IN THE DRAWINGS

TITLE METHODS AND SYSTEMS FOR THE EVALUATION OF POWER
GENERATING FACILITIES

Inventor: Mark Anthony Juneau
Attorney Docket No.: 17410-00010
John S. Beulick Phone (314) 621-5070

FIG. 3

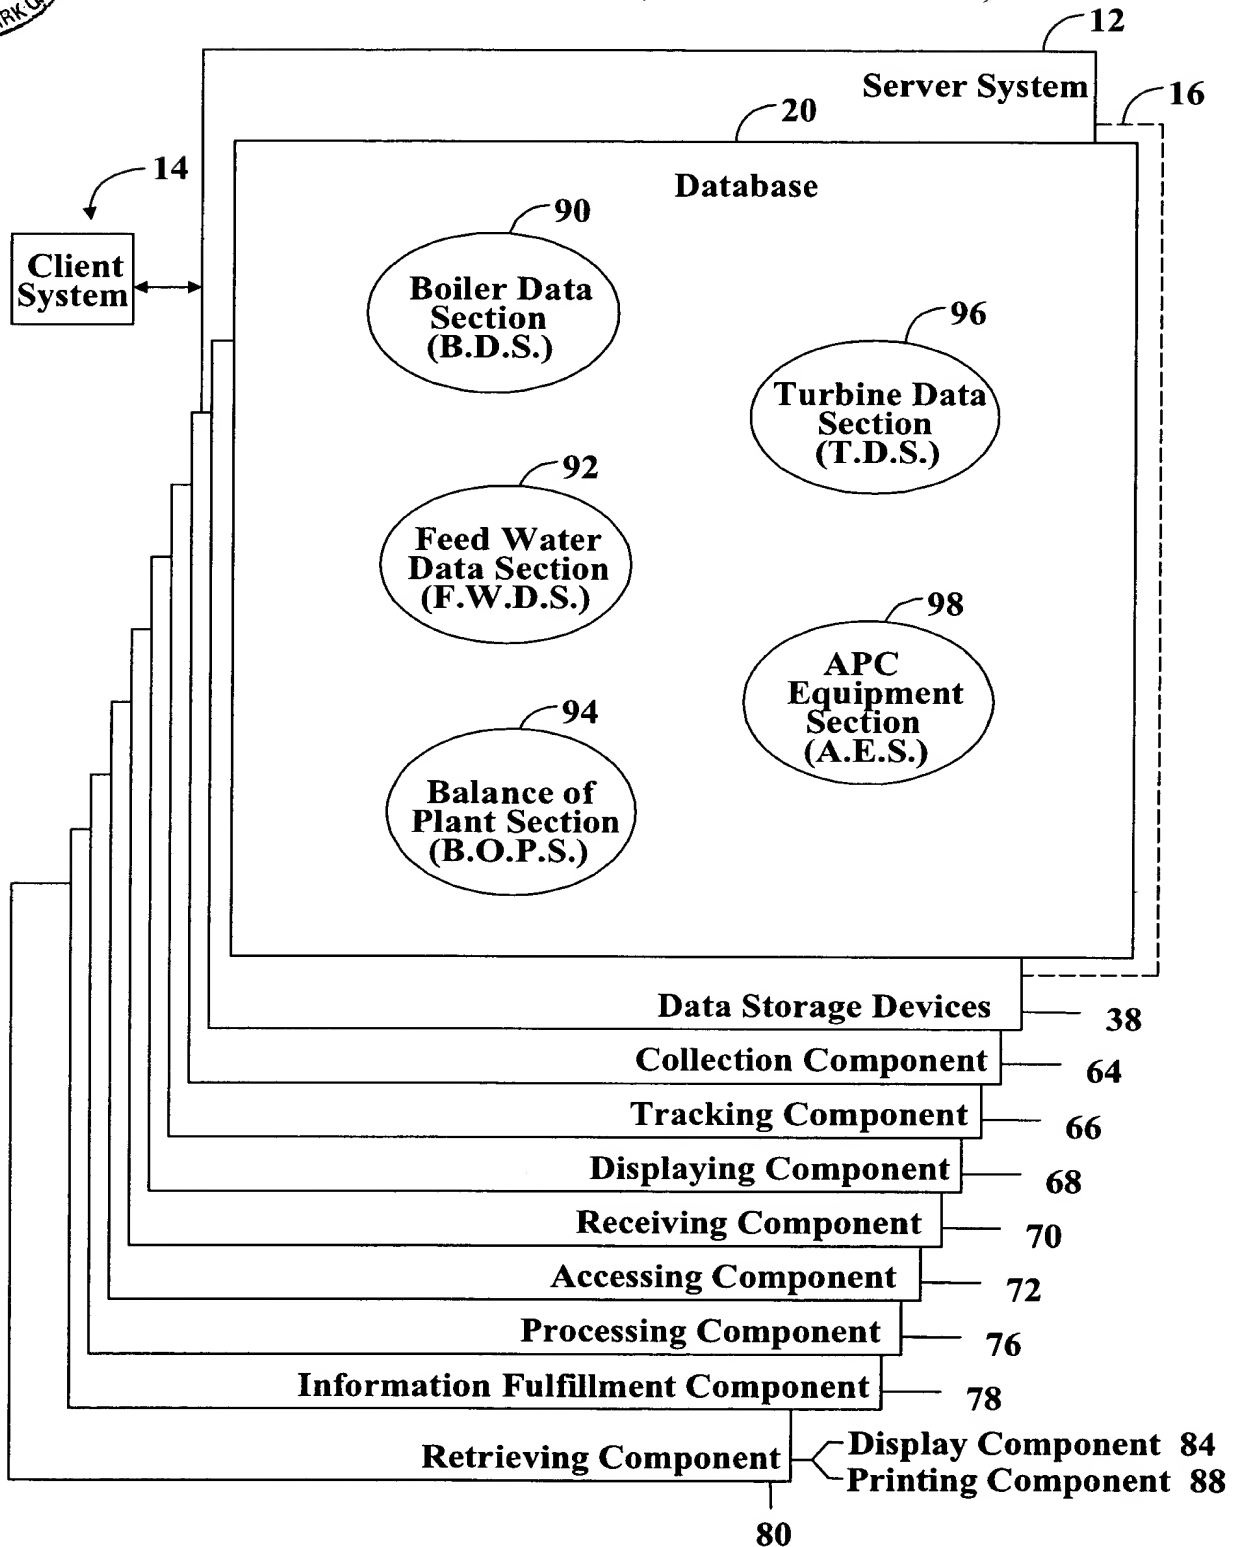
Applicant respectfully requests approval of the following drawing change. Figure 3 has been amended to correspond with the specification. More specifically, “Receiving Component” 80 has been changed to “Retrieving Component” 80 as described in the specification. No new matter has been added. Applicant hereby submits an “Annotated Copy” of Figure 3 showing the requested change in red permanent ink, and a “Replacement Sheet ” incorporating the change to Figure 3.
